**ACTION MEMORANDUM and DECISION DOCUMENT
TIME-CRITICAL REMOVAL ACTIONS,
THREE VOC SITES (SEADs 38, 39, & 40)**

**FINAL
ACTION MEMORANDUM
TIME-CRITICAL REMOVAL ACTIONS, THREE VOC SITES**

**SWMUs SEAD-38, SEAD-39, and SEAD-40
SENECA ARMY DEPOT ACTIVITY**

Response To Comments
Submitted By
U.S. Environmental Protection Agency (USEPA), Region II
For Draft Final Action Memorandum and Decision Document Removal Actions,
Three VOC Sites
(SEADs 38, 39, 40)

FIGURE 1-1
SAMPLE LOCATIONS AND
APPROXIMATE AREA
TO BE REMEDIATED

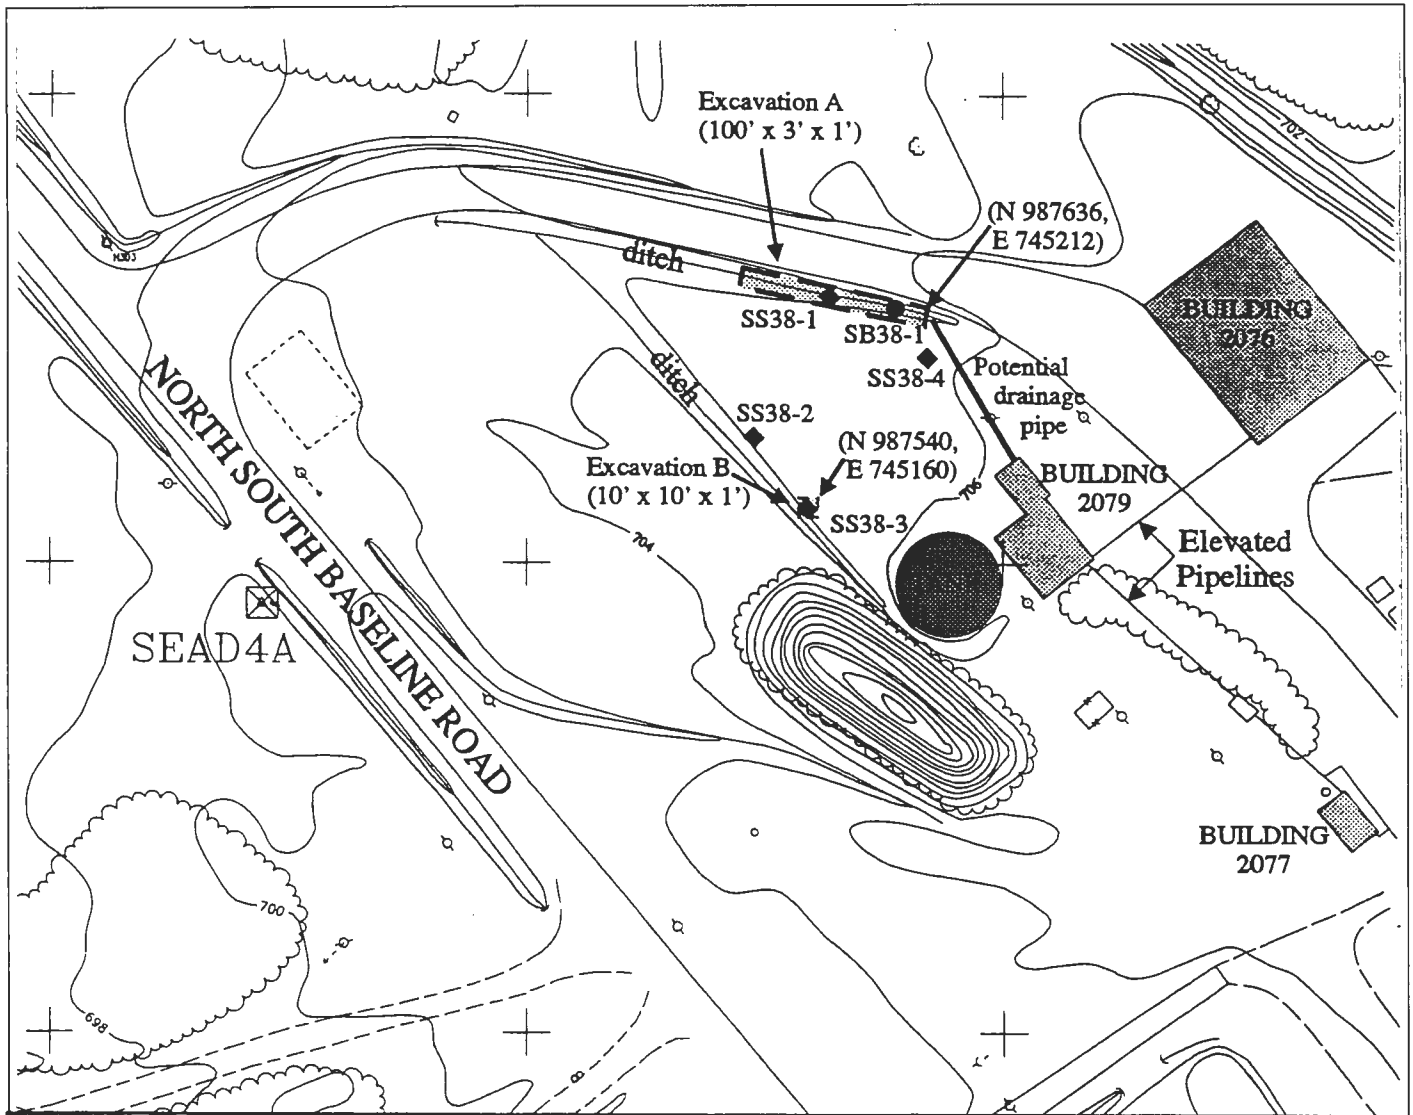
2. **SEAD-38 Decision Document, Table 1-1:** The surface soil samples are labeled "SB" in Table 1-1 and "SS" in the text and Figure 1-1. Revise the ES ID sample designations to be consistent with Figure 1-1 and the text.

3. **SEAD-38 Decision Document, Figure 1-1:** The text in Section 1.1 references the location of the Burning Pit boundary in the description of the areas to be excavated. Add the location of the Burning Pit to Figure 1-1 for clarity.

FIGURE 2-1
SAMPLE LOCATIONS AND
APPROXIMATE AREA
TO BE REMEDIATED

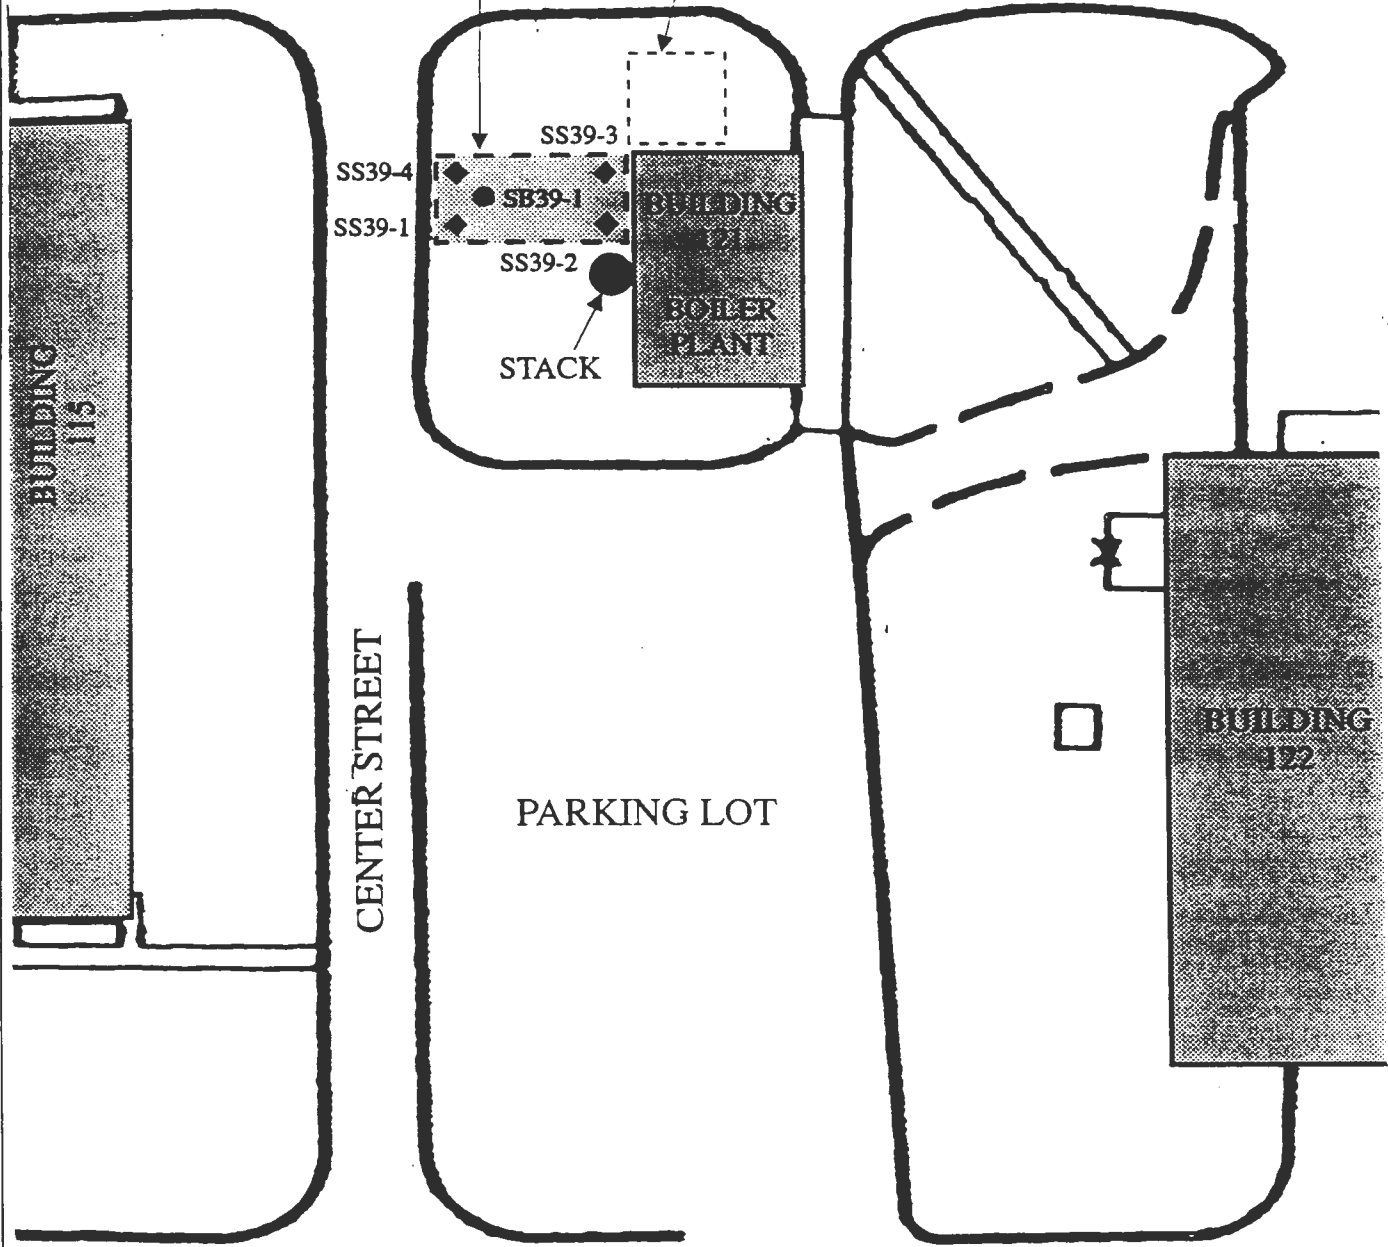
2. SEAD-39 Decision Document, Section 2.1, Page 2-1. The revised text (here as well as other portions of the document) provides substantial clarification. However, it is recommended that the text further be revised to state that each 6-inch layer of soil to be removed is estimated to be 18.5 cubic yards, for a total of 37 cubic yards.

Agreed. The additional text has been added to indicate that the projected volume of each six-inch thickness of soil is approximately 18.5 cubic yards.
